DUBLIN PLANNING AND ZONING COMMISSION

4. **Final Development Plan 01-122FDP - Dublin Jerome High School - Phase 1 - 8300 Hyland-Croy Road**

4. Final Development Plan 01-122FDP - Dublin Jerome High School – Phase 1 - 8300 Hyland-Croy Road

TREE REPLACEMENT PLAN
SCALE: 1" = 100'

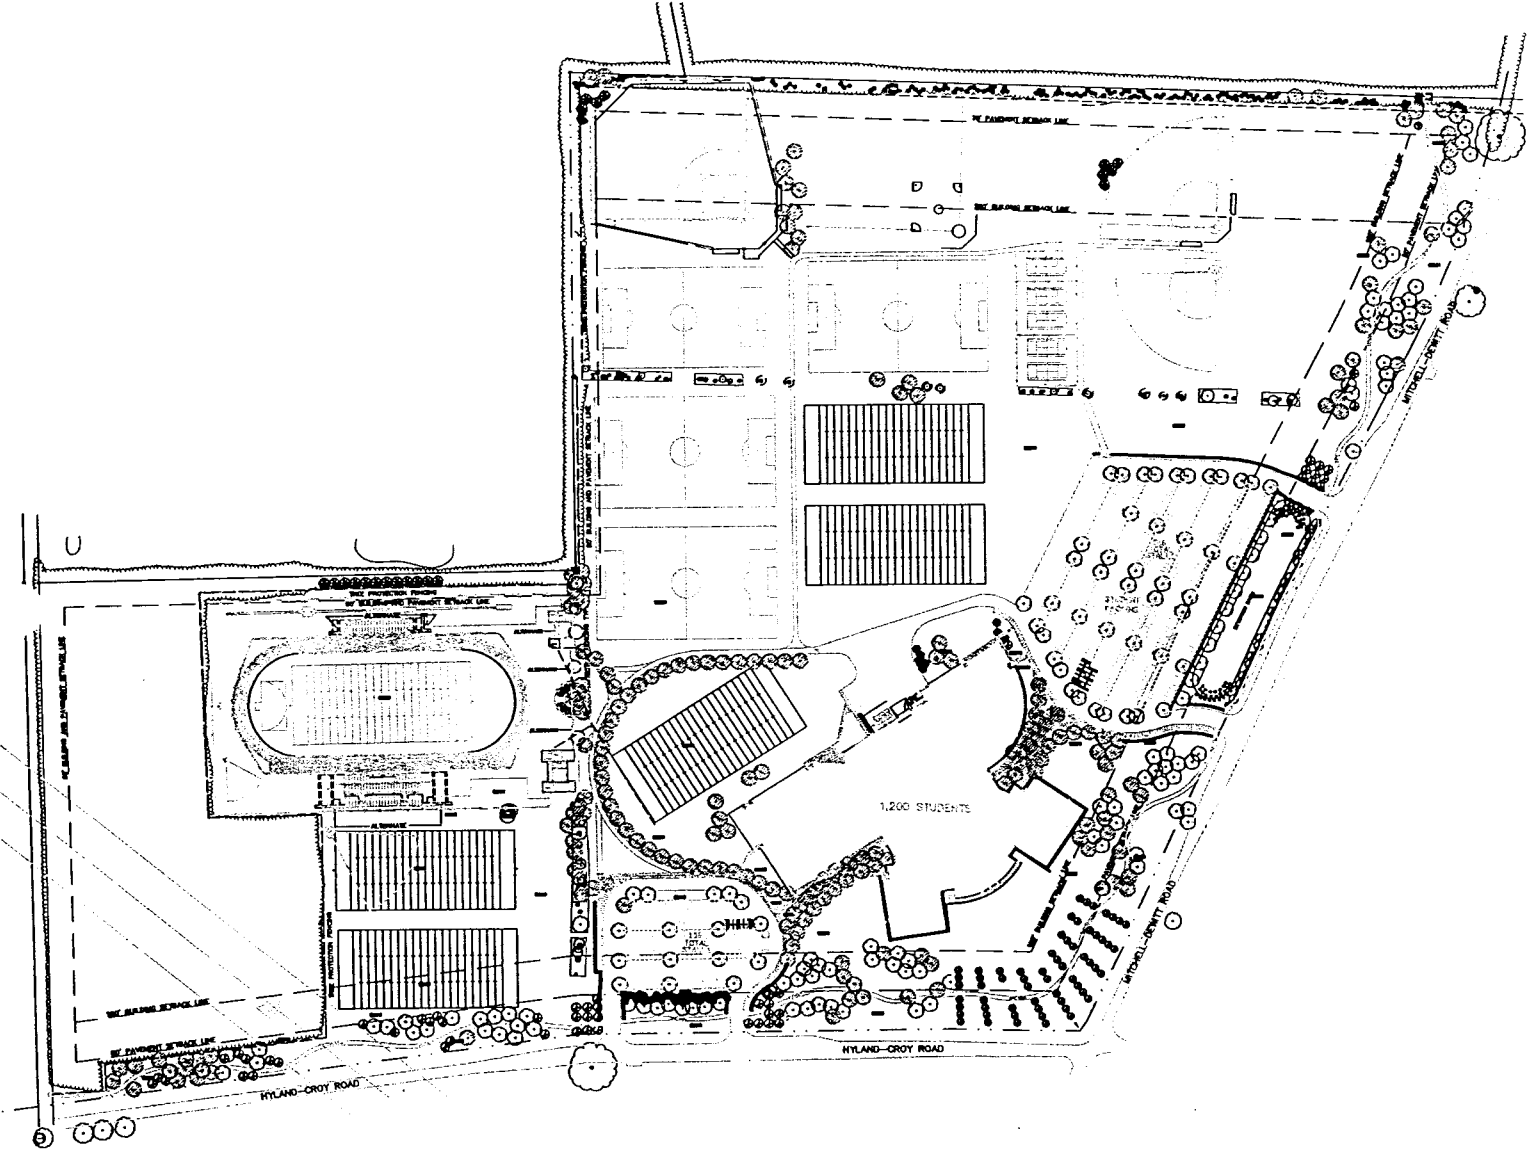
- One of the conditions of the preliminary development plan approval stated that all requirements of the tree replacement plan need to be met unless waived by Council. The applicant was granted a partial fee waiver of \$262,475 to the Tree Preservation Ordinance for the removal of protected trees. This waiver does not include trees damaged in construction nor does it include trees that were not initially bound for removal.

- The proposed location of the athletic complex results in the removal of a large number of protected trees. However, the benefits of using this tree stand to screen the stadium, as well as reduce the light trespass, are desirable long-range goals of the plan. The staff and Commission both agreed with this location choice at the rezoning stage.

Staff has examined this request under Council's adopted tree waiver policy. The policy states that a "tree-for-tree" replacement can be used for non-landmark trees if certain criteria are met. Landmark trees are still subject to an inch-for-inch replacement under Council's policy. Staff has found that the plan complies with all development standards, and that the placement for the various school elements preserves a major portion of the tree rows and the northernmost tree stand.

The straight application of the Code would require planting 1,180 (2.5") new trees. The adopted City Council guidelines would still require planting 663 (2.5") new trees. The submitted proposal adds 191 replacement trees, which is a slightly smaller caliper than the Code minimum. The placement of the various school components (school, stadium, parking, etc.) preserves most of the trees on the site. This proposal falls short of City Council's guidelines, but the school system has generally not been expected to meet all "developer" requirements.

- 1) That a more detailed tree survey, preservation plan and replacement schedule be submitted, including the 10-foot swath around the current tree protection fencing shown on the plans, subject to staff approval;
